BOARD OF SUPERVISORS
AGENDA LETTER

SUBJECT: Rice Ranch Specific Plan Amendment regarding the Stubblefield Rd Connection

RE: *Rice Ranch Specific Plan Amendments Regarding the Stubblefield Road Connection, 06ORD-00000-00016*

**RICE RANCH SPECIFIC PLAN AMENDMENT FOR THE STUBBLEFIELD ROAD CONNECTION
CASE NUMBER 06ORD-00000-00016
ADDENDUM TO ORCUTT COMMUNITY PLAN EIR (95-EIR-01) and
RICE RANCH SPECIFIC PLAN SUPPLEMENTAL EIR (03-EIR-05)**

Figure 3.1
Preliminary Design of Stubblefield Road Connection

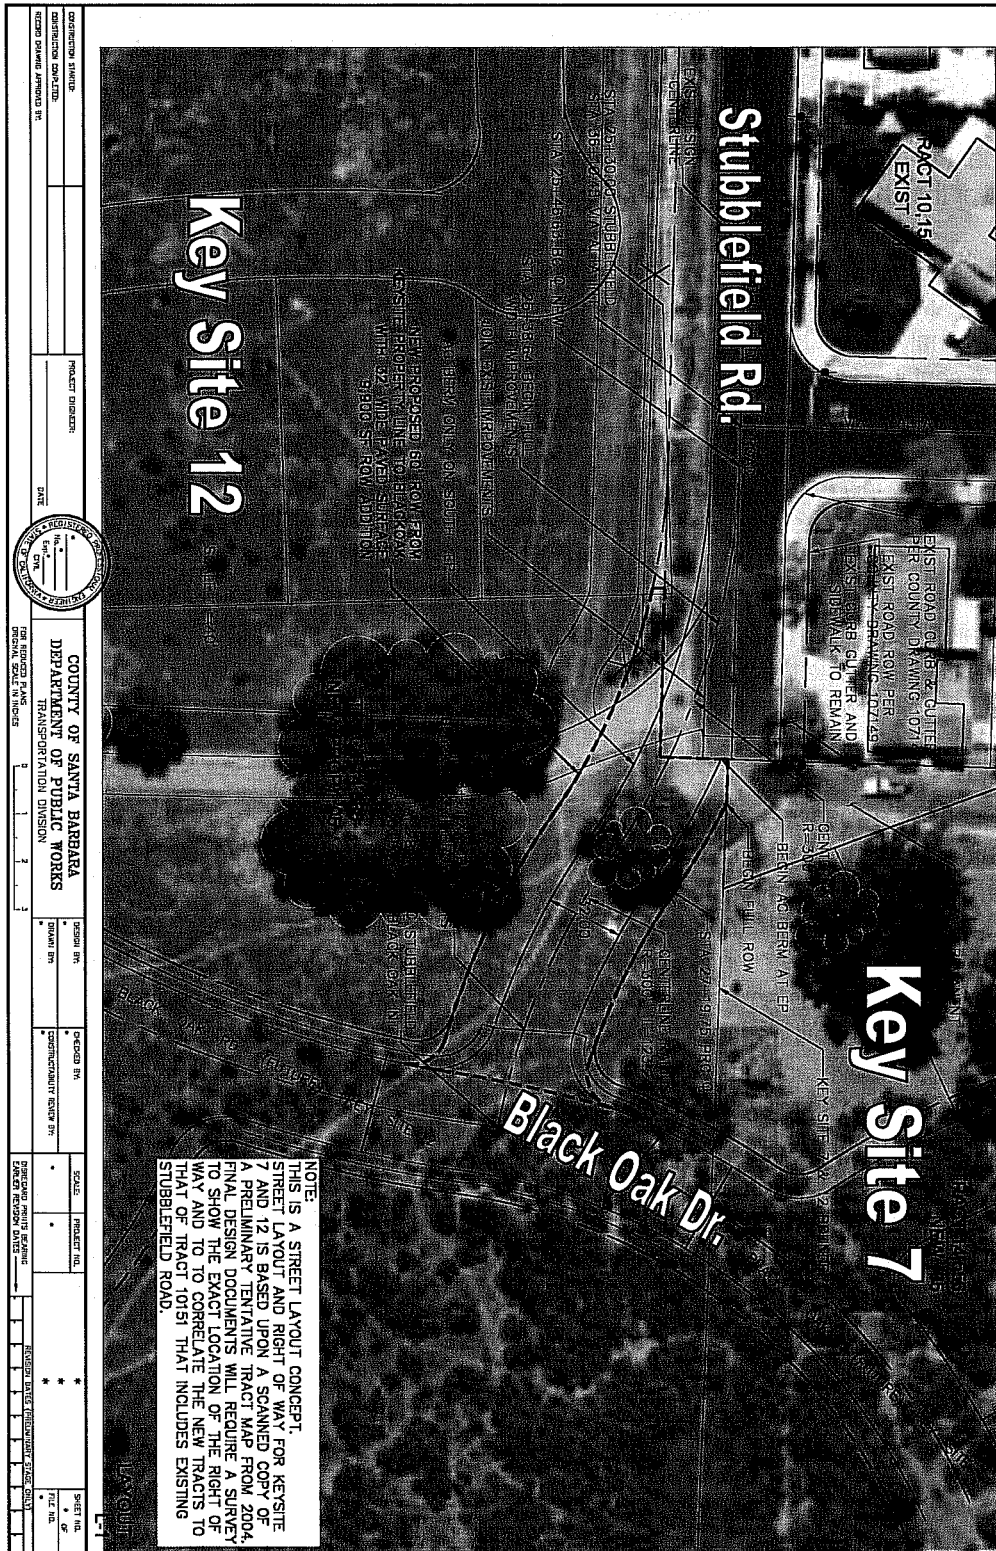
The proposed road would be 160 feet long. The connection would be located between the Stubblefield Road terminus and Black Oak Drive through the proposed 1.39-acre neighborhood park in the eastern portion of Rice Ranch (Key Site 12). The proposed project would include linking the proposed class II bikeway along Black Oak Drive to a proposed class III bikeway along Stubblefield Road. Construction of the roadway connection would require approximately 6,400 square feet of space within the park; the remaining park acreage would still maintain the minimum 1 acre size requirement, pursuant to OCP Key Site 12 Policy KS12-2.b and the Rice Ranch conditions of approval. The project would conform to the current plans for Black Oak Drive by providing a "T" intersection design and a 1-way stop along Stubblefield Road at Black Oak Drive.

Proposed map modifications

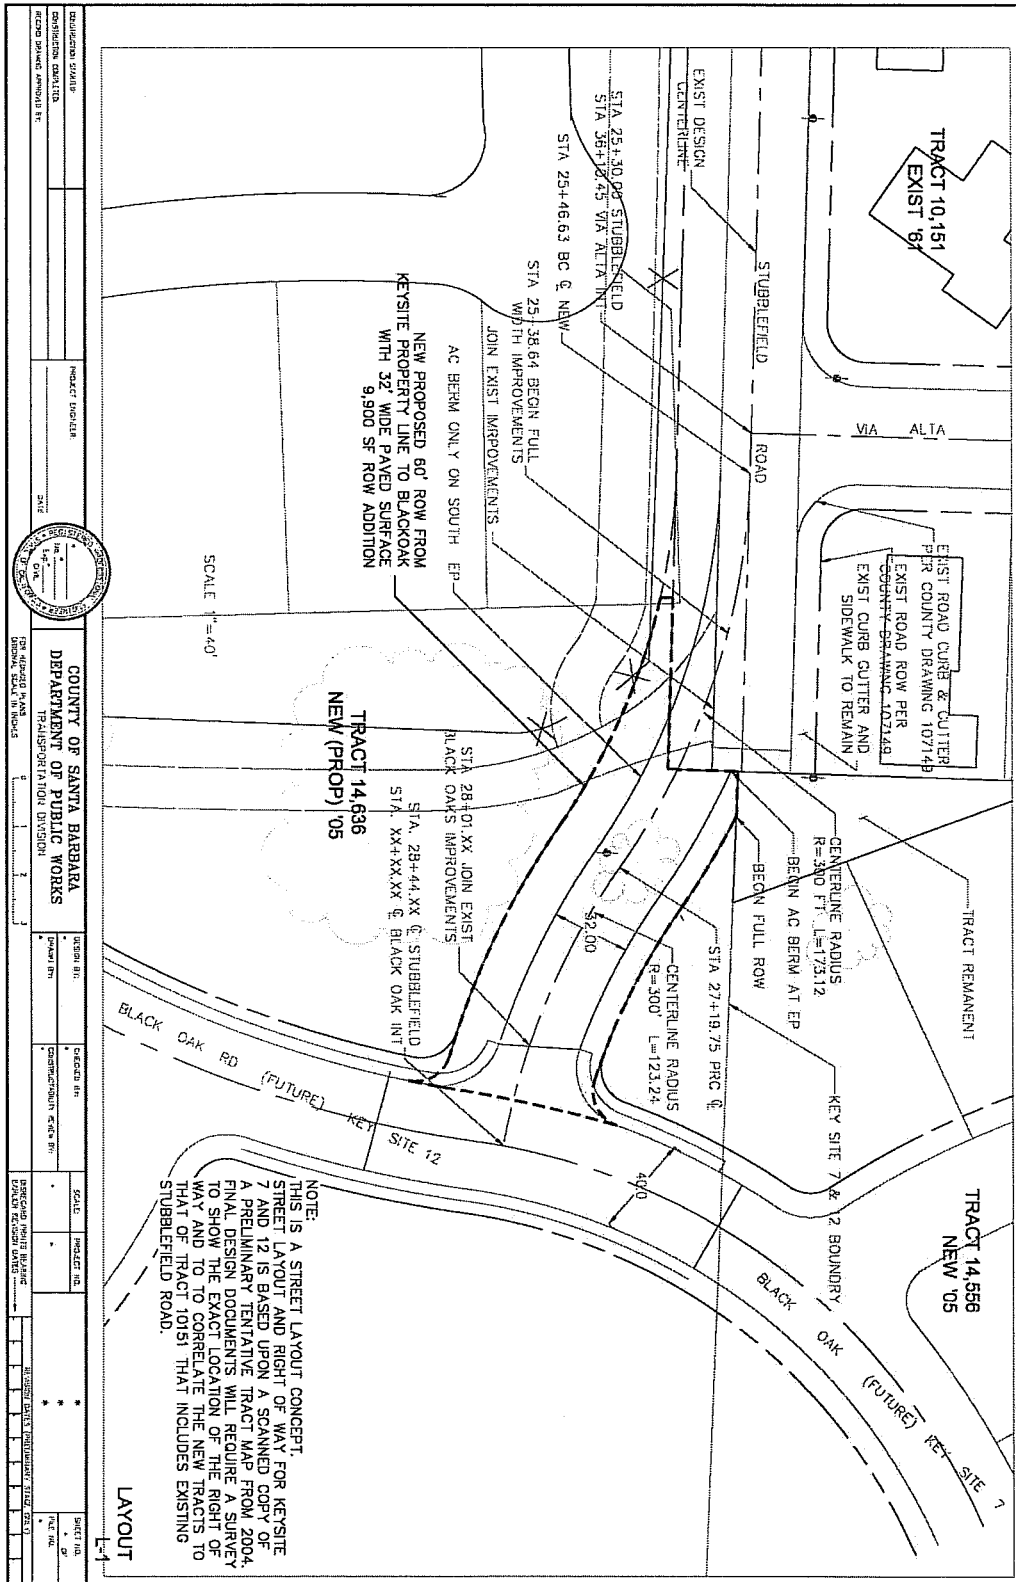
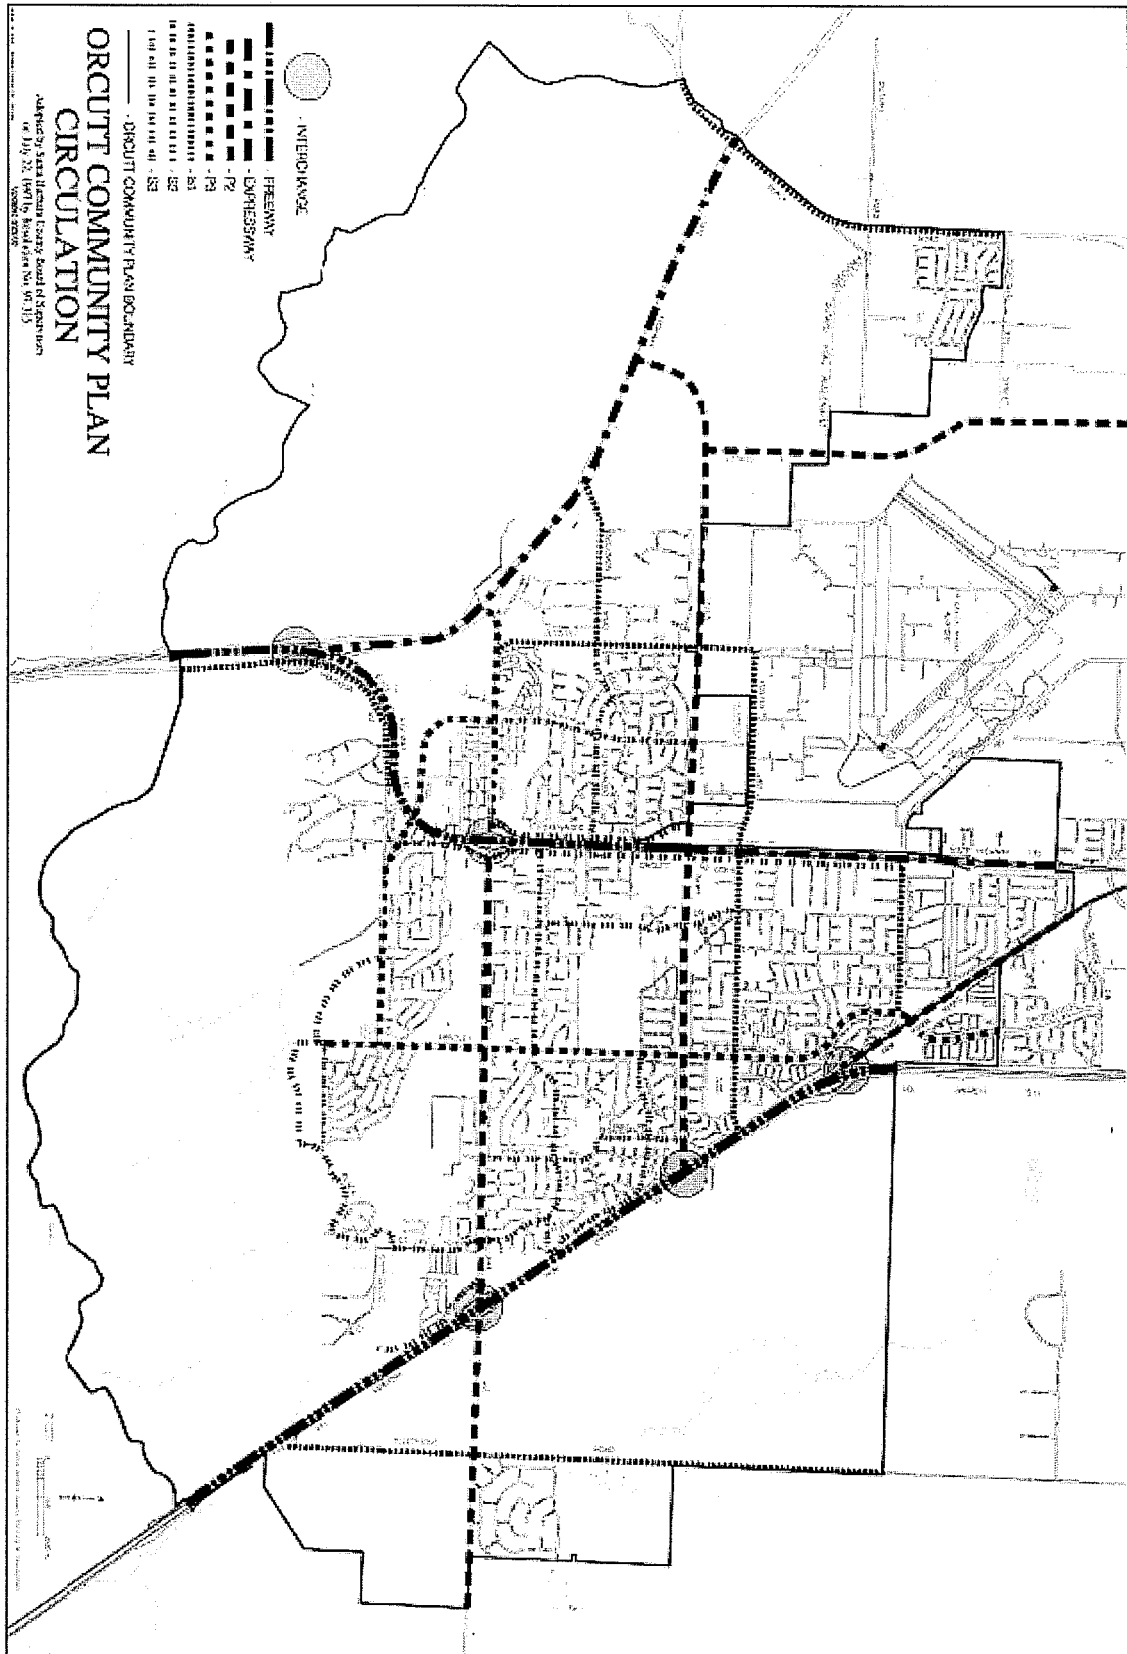
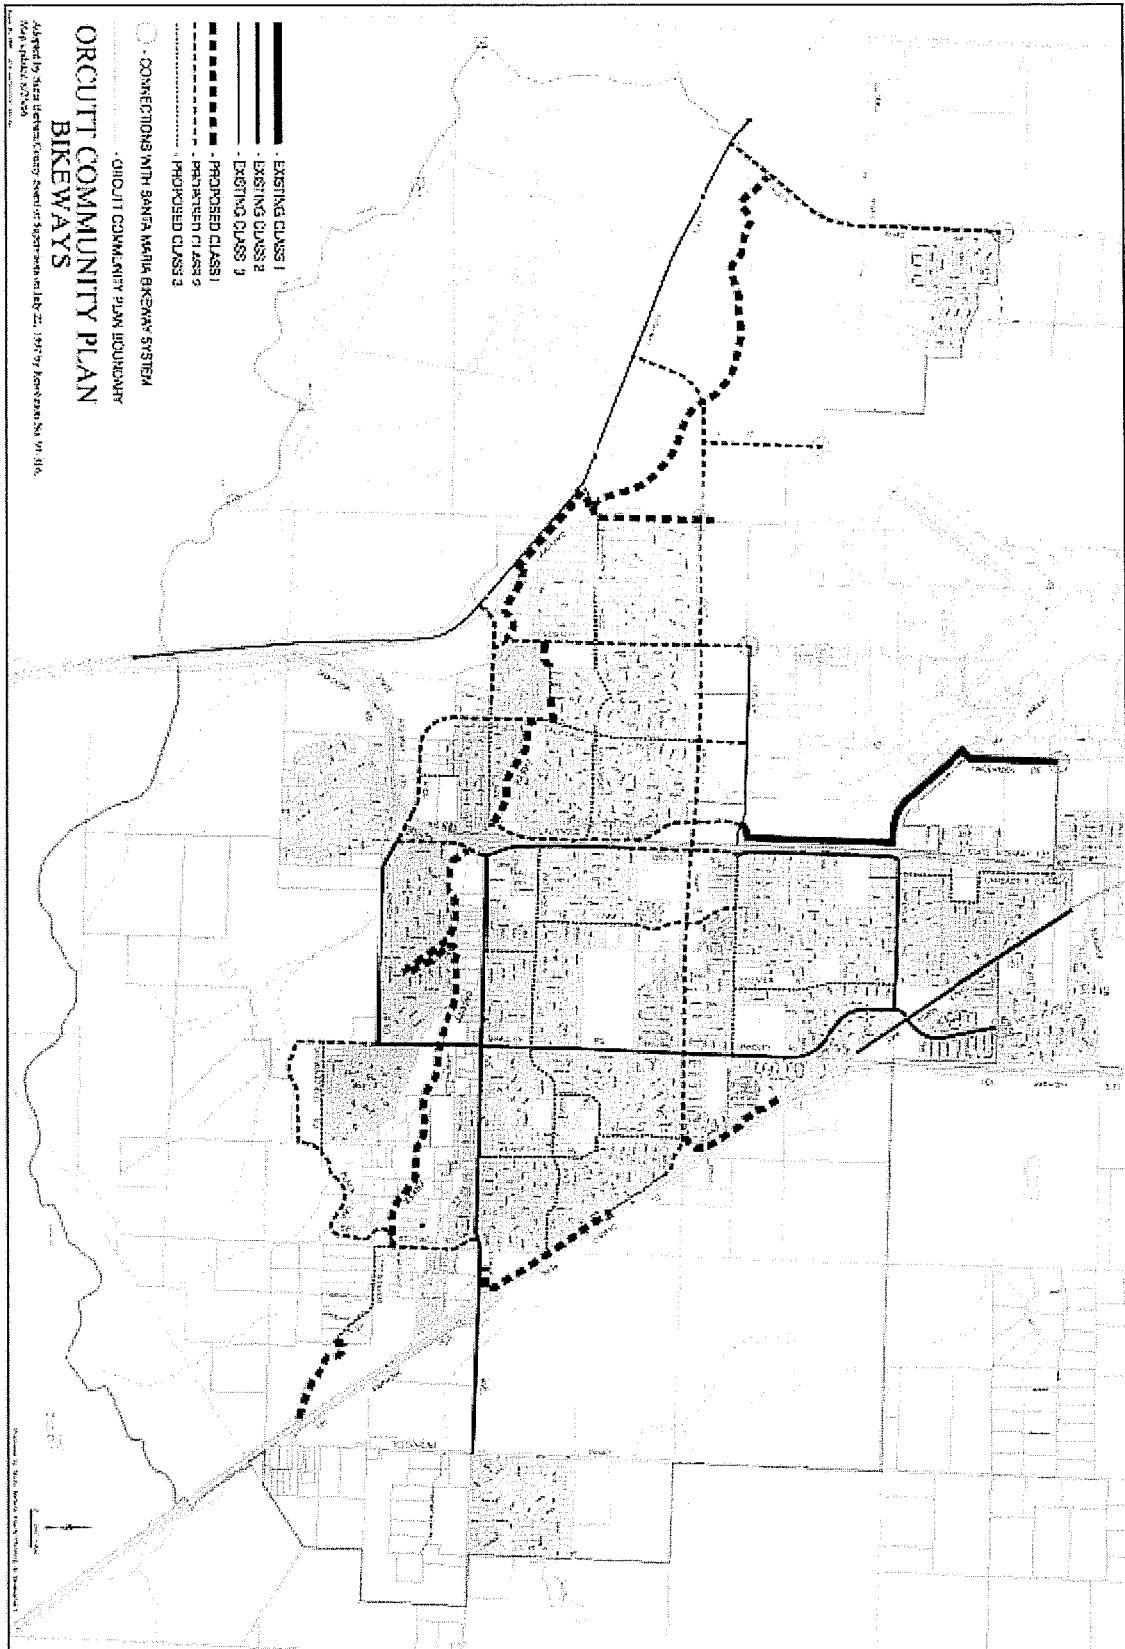
The following maps and figures shall be viewed in a manner which includes the extension of Stubblefield Drive through the Grove neighborhood pocket park as depicted in the three maps above.
